RE: 258 Union Avenue

NEIGHBORHOOD CONTEXT

ISSUES AND CONCERNS

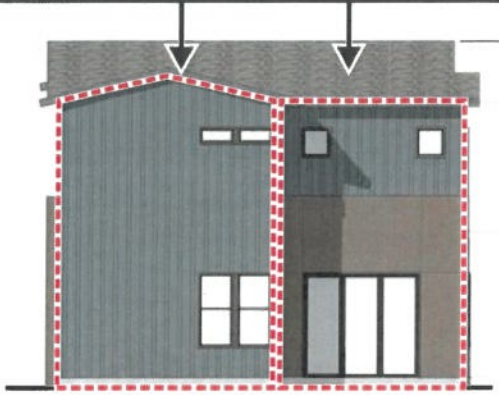
5. The front facades of residential units 1 and 6 are relatively unarticulated compared to those of the nearby multifamily development - see photo below.

4. Relocate the entries to residential units 1 and 6 to the street-facing facades to be consistent with Residential Design Guidelines 3.6.1, and utilize generous entry porches as were proposed on the last development proposal for this site.

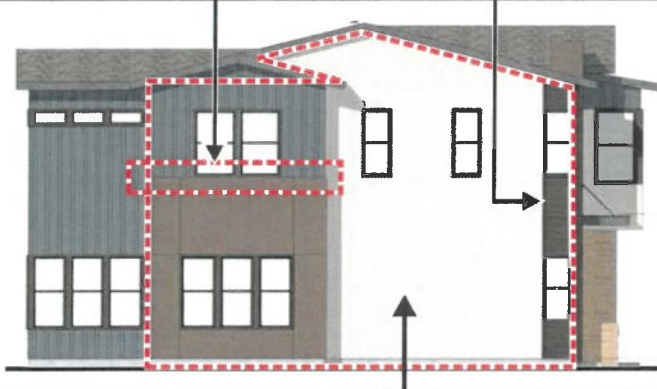
9. The two-story unbroken walls on the rear elevations of the single family units facing neighboring properties would not be consistent with the Residential Design Guidelines.

Unbroken two-story walls facing neighbors would not be consistent with Residential Design Guidelines 2.3.6 and 3.3.3

5. Address the issue of the two-story walls facing neighboring development.
6. Reconsider the use of glass paneled garage doors.
7. Address the many conditions where material changes are made in the same plane or at outside corners on both portions of the development, and address the issue of stone used only on the front facades of the single family homes. This may require some simplification of the palette of siding materials and/or some additional facade plane changes.

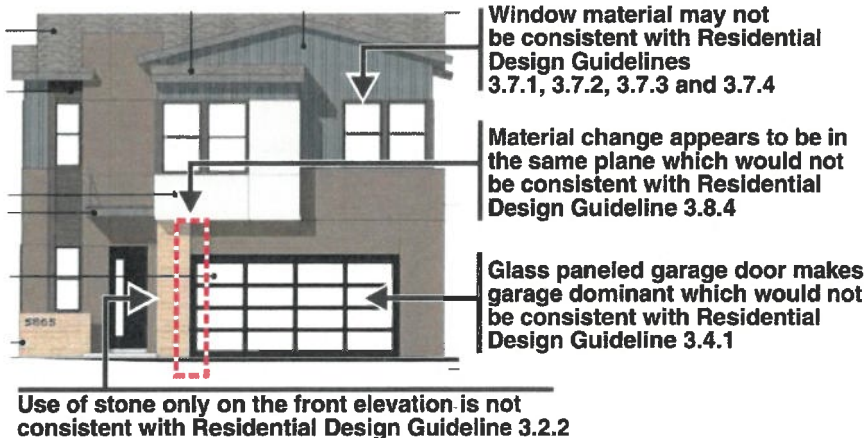
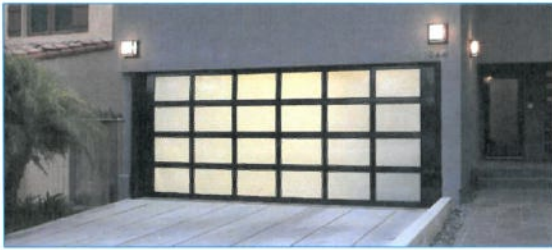
Material changes appear to be in the same plane which would not be consistent with Residential Design Guideline 3.8.4

This street-facing facade is not very visually engaging and would not be consistent with Residential Design Guideline 3.3.2

Glass paneled garage door examples

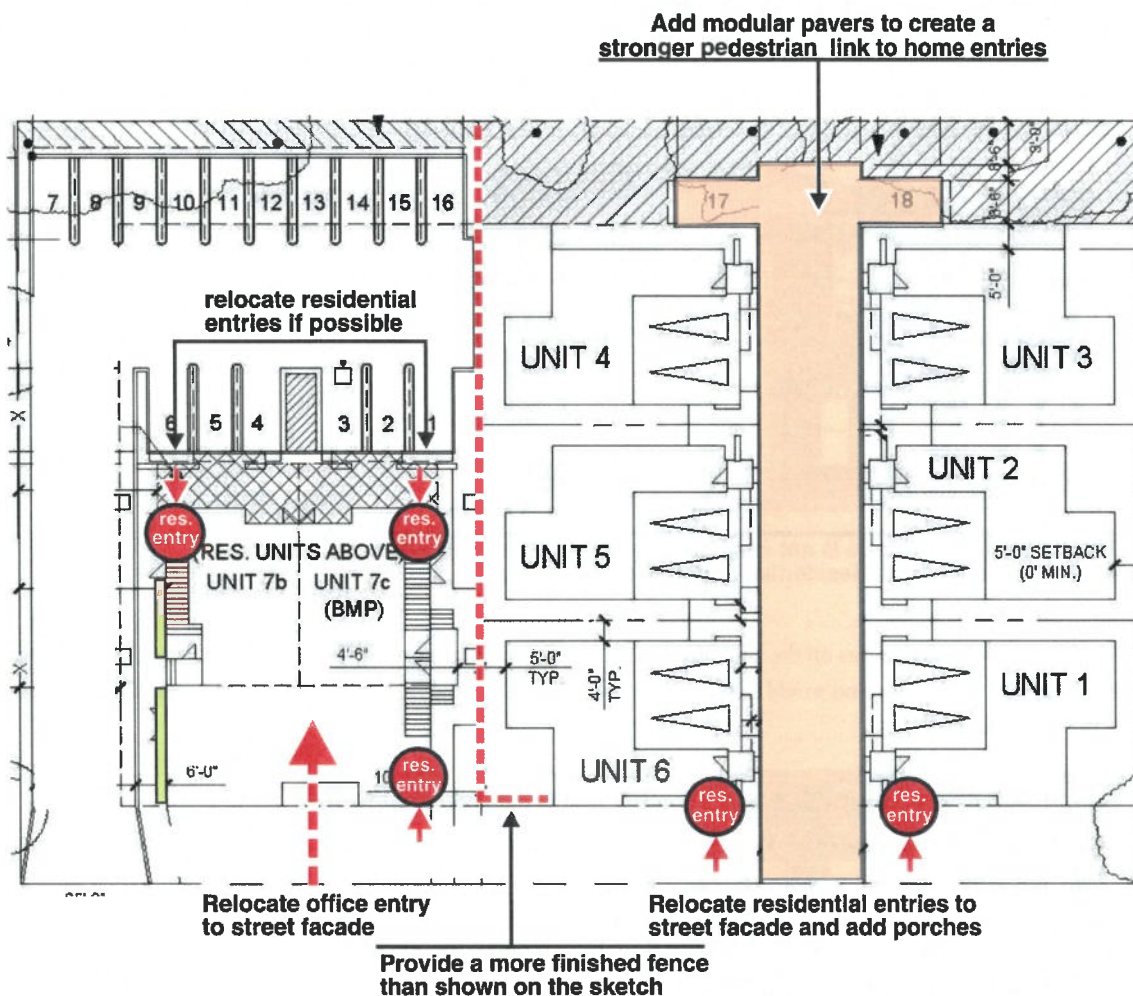
10. The glass paneled garage doors on the auto court of the single family homes would make the garages the most prominent feature of the facades, and would not be consistent with Residential Design Guideline 3.4.1 - see photo example on the following page.
